Access Compliance Report

Public Rights-of-Way

Intersection ID: 47833	Main Street: TOM_SHORT_RD	Cross Street: SPUR_RANCH_RD	Location: NE
ADA ID: AF7A55560A9E	Ramp Type: PerpDiag	Initial Pass/Fail: Fail	Overall Compliance: No
Severity Score: 21.25			
Codes/Mitigation Info/Possible Solution		Field Measurements/Component Compliance

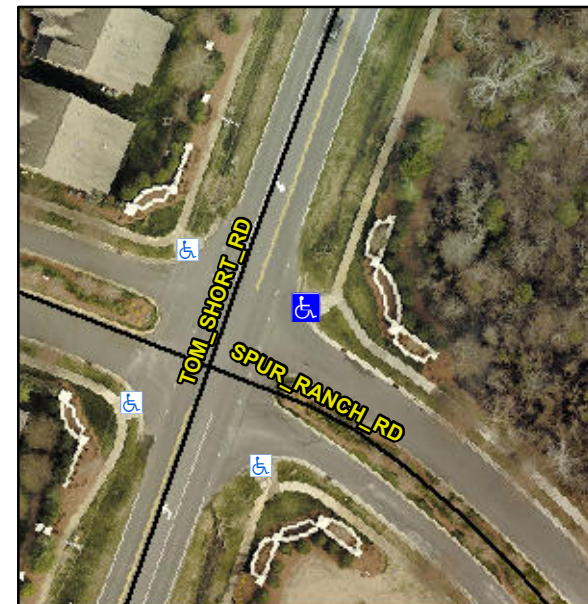
Remove & Replace Curb Ramp With Two New Directional Ramps or Equivalent.

R304.5.1, R304.2.2
